DEVELOPMENT REVIEW COMMITTEE (DRC) COMMENT REPORT

PROJECT NAME: 300 W. Broward

CASE NUMBER: UDP-S21052

REQUEST: Site Plan Level II Review: 956 Multifamily Residential Units, 23,752 Square Feet of Commercial Use with associated Parking Reduction Request in the Downtown Regional Activity Center

Principles of Building Design

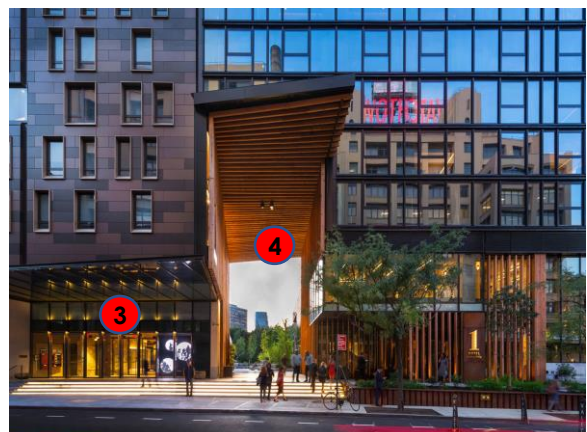
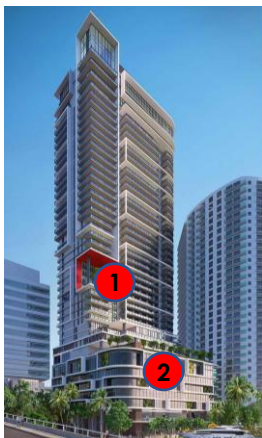
- d. Tower floorplates for levels 36 and above exceed the maximum floorplate size. Project narrative does not contain justification for this request nor how it meets the design intent.
- e. Building height is proposed 558 feet, which exceeds the maximum permitted by the FAA;
- f. Building tower doesn't comply with tower placement outlined in the DMP based on the tower placement being similar to an L-shape tower configuration;
- g. Tower balconies encroach into the setback as well as the tower separation distance, which needs to be shifted accordingly;
- h. The project does not maximize active uses with an 'extroverted' ground floor with retail in a strategic location along Broward Boulevard as there are no pedestrian entrances to the retail along Broward Boulevard;
- i. Provide for continuous pedestrian shading canopies at a minimum of 5 feet in depth; and

- j. Proposed tower does not meet DMP intent for skyline drama;
 - k. The tower top design should be revised to provide for greater expression, varying in design, contain sculptural features, and illuminate;

- m. Proposed parking podium screening is not adequate as there is not enough design detail to understand the application of the screening material which should include product information and images, percentage of openness, and design approach.

1 Vertical banding 2 Garage Screening 3 Pedestrian/Ground Level 4 Building Material

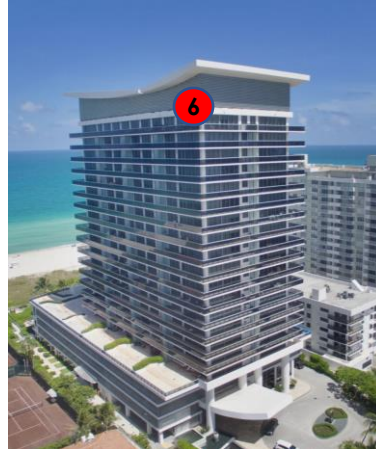
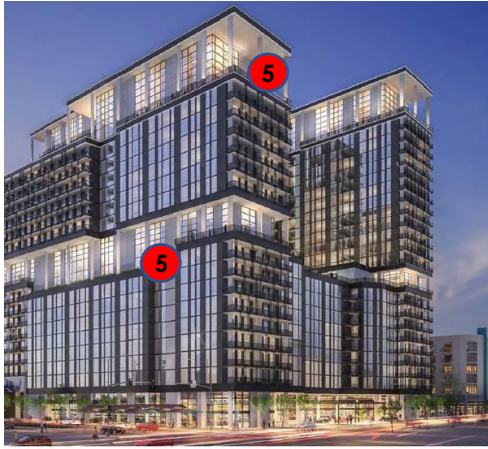
12. The proposed building design needs to be revised to address the following. Refer to images below as design examples;
- a. The requested site deviations for increased podium height, increased building height, larger floorplates, collectively create issues with the design intent established in the DMP. Appropriate placement and compatible building design are important for this site given the context and visibility. In addition, the balconies encroach in the tower separation distance and building setbacks, which only furthers the enormous appearance of the building. Applicant should re-examine the overall building design;

- b. The building is significantly larger in mass and scale than the immediate surroundings. Mitigate building mass by incorporating a stepback along Broward Boulevard and provide transition in the design by scaling the building back from southern property line, paying particular attention to the distance and proximity to the historic district. Include architectural elements that increase the visual interest of the building such as vertical banding, tower verticality, etc.

- c. The lower levels of the building at pedestrian scale, should be redesigned to incorporate a significant floor to ceiling height in relation to the overall scale of the building and should continue along the full streetwall length of the building. Building corners should contain significant architectural features that are proportionate to the overall project scale with significant projections, change in material, and other design techniques, cut-through passageways, etc.;

- d. Tower top design does not achieve the design intent outlined in the DMP for dramatic skyline composition nor does it contain a sculptural design, unique feature, or angular element. Revise the top of the tower to meet this intent;

- e. Additional high-quality building materials are needed for this project especially the lower levels and parking podium; and
 - f. Location of the garage ramp seems to impede the full use of the retail space proposed on the ground level fronting Broward Boulevard and it is unclear how visible the ramp will be from the street. Address this issue.
